SUBJECT Update requested to the Auckland Unitary Plan
(Operative in Part 2016) (AUP)

Reason for update	Alteration to designation confirmed
Chapter(s)	Chapter K Designations Kiwirail Holdings Ltd
Designation only	
Designation 6302	North Island Main Trunk Railway Line
Locations:	North Island Main Trunk Railway Line from Buckland to Britomart Station, Auckland Central
Lapse Date	Given effect to (i.e. no lapse date)
Purpose	The purpose of the designation is to develop, operate and maintain railways, railway lines, railway infrastructure, and railway premises as defined in the Railways Act 2005.
Changes to text (shown in underline and strikethrough)	- Amending text for Condition 21: 21. Prior to the operation of the Third Main, the Requiring Authority shall install noise barriers on the western side of the NIMT to mitigate rail noise received at Existing Buildings identified in condition 20. The noise barriers shall ensure the increase in rail noise level as a result of the operation of the Third Main is less than 3 decibels and shall be: a. at least 3.8 metres in height above rail track level within the rail corridor between points: i. 659+715 and 659+926 of the NIMT (works in vicinit

Barrier required under Condition 21 – refer Appendix C Sketch – Cross Section a Ch662+50 at 52 Rosella Road [taken from AEE]

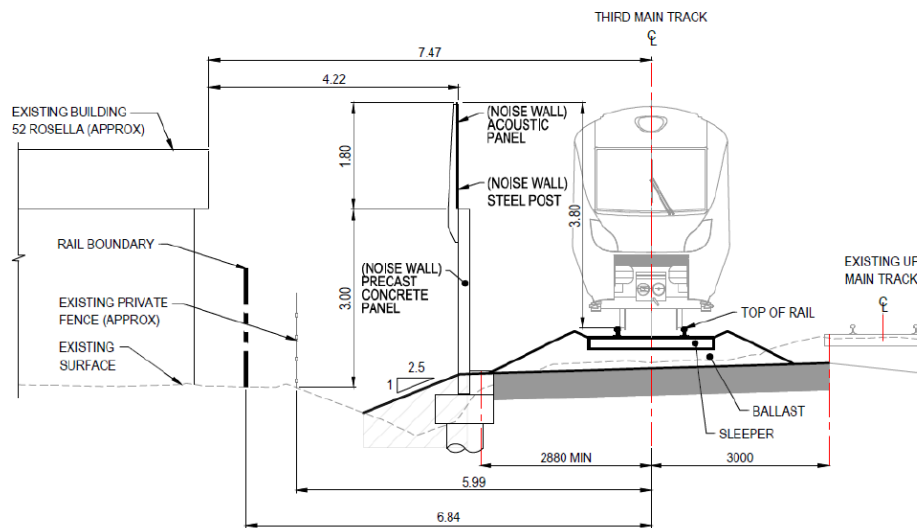
KiwiRail also advise that further investigations have revealed that 3m of the barrier is now required to be solid due to construction requirements related to the height of the retaining wall, as demonstrated in Figure 2-2 (below). In brief, while a retaining wall between the Third Main’s rail tracks and the adjacent residential properties is still proposed to support the railway track, the level of the top of the retaining wall relative to the level of the Third Main track along the section between 62 and 50 Rosella Road is different to the levels shown in drawings submitted with the 2020 NoR (being sheets 77 and all of those between 256-271). This means that the height of the barrier and the transparent section of the barrier assessed in the 2021 Boffa Miskell assessment is different (i.e. taller) as the retaining wall will be up to 1.8m high in some places. 3m of the barrier is now required to be solid due to construction requirements and foundation conditions, whereas it was originally planned that the barrier could be constructed of Perspex apart from the bottom 1.1m which would have been solid.

- If the noise barrier were constructed, the additional height of the barrier and the closer proximity of the rear dwellings at 50, 52 and 54 Rosella Road would result in greater visual bulk and poorer light permeability effects than what was originally assessed in the Boffa Miskell visual assessment.
- The proposed alteration to remove the requirement for the noise barrier would maintain the existing view of the rail corridor from the dwellings.

Through this NoR, Kiwirail seeks to alter Condition 21 to remove the requirement to construct a noise barrier along 48, 50, 52, 54, 56, 58 and 62 Rosella Road, Mangere East. To mitigate noise produced by the operation of the third main line at 52 Rosella Road in accordance with Condition 20, Kiwirail has obtained written approval from the owner of 52 Rosella Road to provide acoustic upgrades to the rear dwelling as an agreed alternative to the noise barrier.

Figure 2-2: Barrier required under Condition 21 - refer Appendix C Sketch – Cross Section a Ch662+50 at 52 Rosella Road

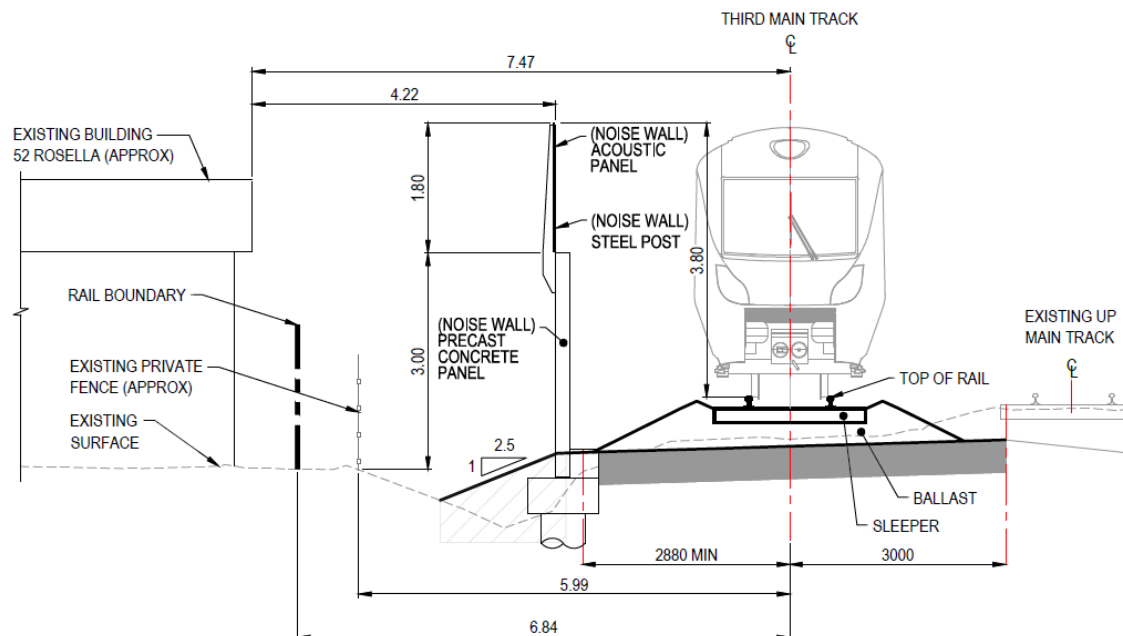
Figure 2-2 below is a graphic representation of the barrier as required under Condition 21 currently as it relates to the second dwelling located at the rear of 52 Rosella Road. The figure shows that due to the height of the Third Main in this location a 3.8m barrier above rail track level at 52 Rosella Road, would result in a barrier 4.8m high as seen from the dwelling. 3m of the barrier is now required to be solid due to construction requirements and foundation conditions, whereas it was originally planned that the barrier could be constructed of Perspex apart from the bottom 1.1m which would have been solid. This barrier would be 4.2m away from the dwelling. It is also relevant to note that the figure shows that the existing private fence is located approximately 1.9m inside the rail designation (the relevance of this is discussed in Sections 3 and 4.1).

The design of the barrier in this location given the combination of the height of the Third Main rail tracks, and the proximity of the rear dwellings results in what appears to be a more severe potential visual effect than initially considered. The differences identified as a result of further investigations/detailed design are that the barrier will be a taller solid concrete barrier when located on top of the retaining wall as shown in Figure 2-2, with the transparent section of the barrier will be higher than assessed in the May Assessment. In addition, the wall is closer to the properties and dwellings than previously assessed.

Installing the barrier as required by the condition will have a visual effect. While there was a high-level assessment of that effect included in the KiwiRail evidence for the hearing, the form of the barrier as shown in Figure 2-2 in relation to 52 Rosella Road and its distance from the dwellings at the rear of 50, 52 and 54 Rosella Road, has been reassessed due to the barrier having additional adverse effects. Not providing the barrier would have a better visual outcome for the owners and occupiers of these properties.

In summary, the amendment removes the requirement for the barrier adjacent to the southern end of 48 Rosella Road and the full boundaries of 50, 52, 54, 56, 58 and 60 Rosella Road (as shown in Figure 2-1).

Diagram showing location of noise wall adjacent to railway line

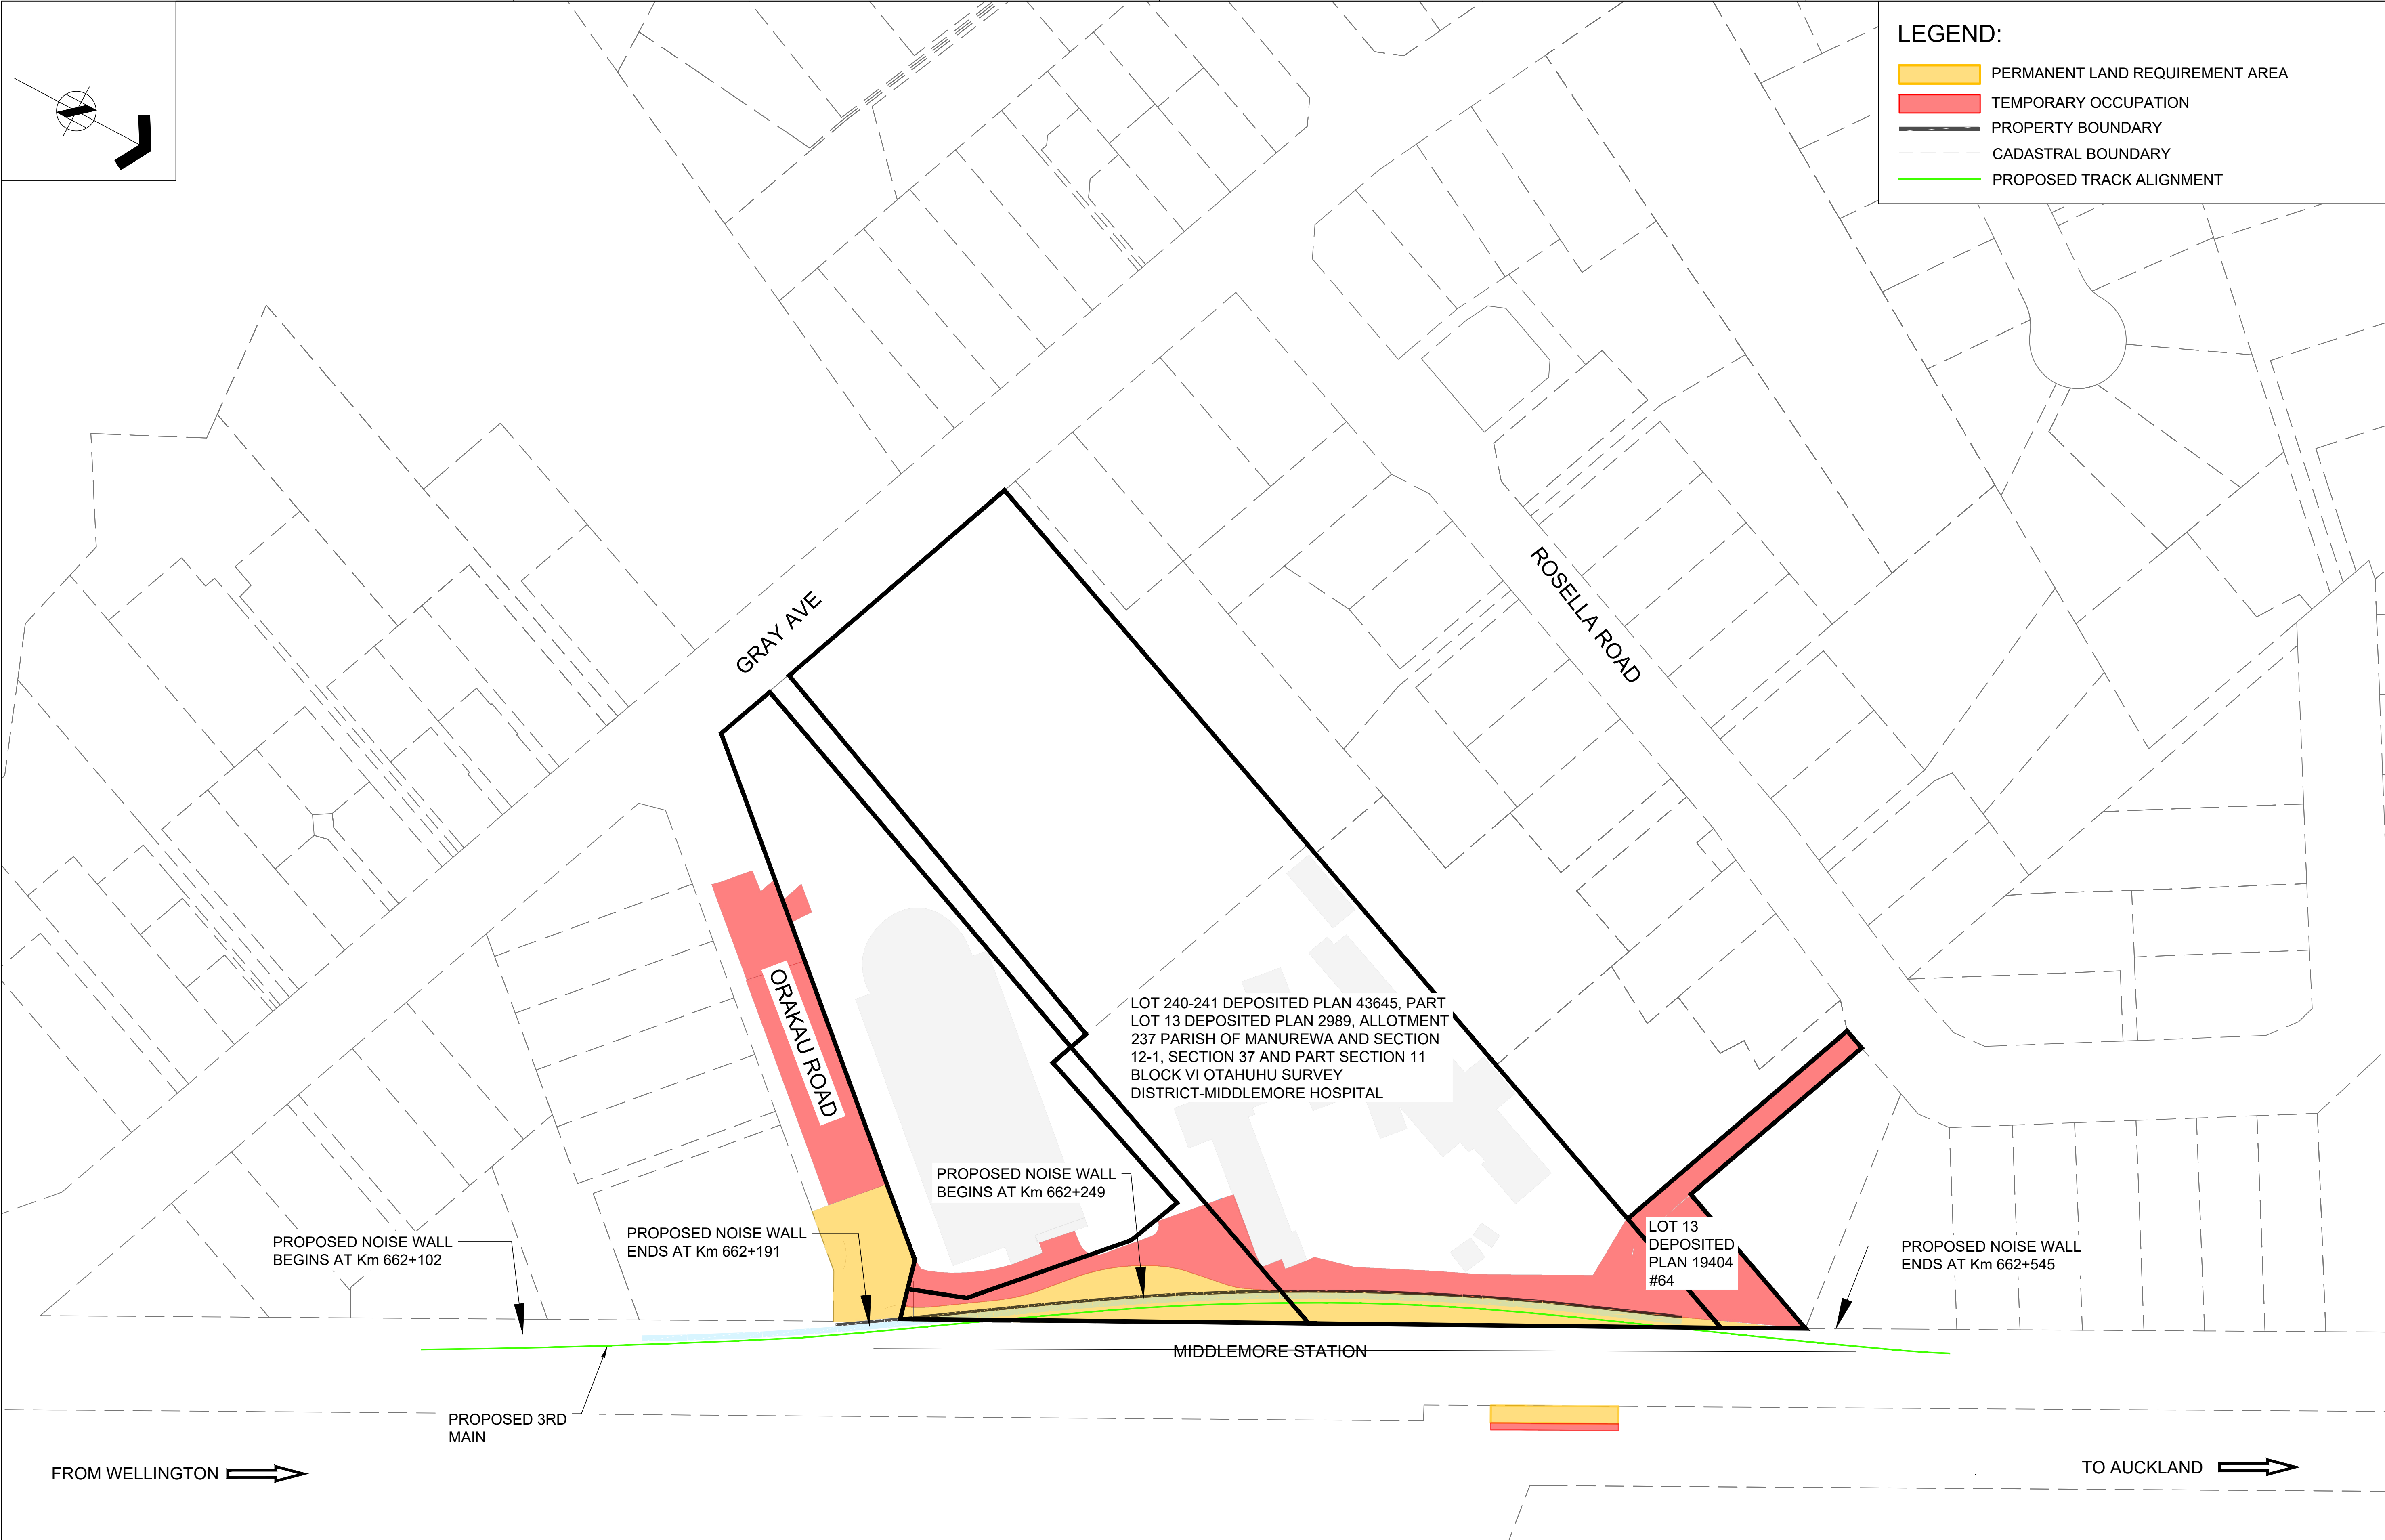
d. constructed in general accordance with the memorandum from Boffa Miskell (Oliver May) dated 30 November 2021.
Changes to diagrams	• See Attachment B – amended diagram showing noise wall location adjacent to railway line • Replaces page 16 of existing designation
Changes to spatial data	No changes required.
Attachments	• Attachment A: Alteration D6302 North Island Main Trunk Railway Line – s181(3) Report and Decision • Attachment B: Diagram showing location of noise wall adjacent to railway line • Attachment C: Updated Kiwirail Holdings Ltd Designation 6302 North Island Main Trunk Railway Line (strikethrough/underscore) • Attachment D: Updated Kiwirail Holdings Ltd Designation 6302 North Island Main Trunk Railway Line (clean)
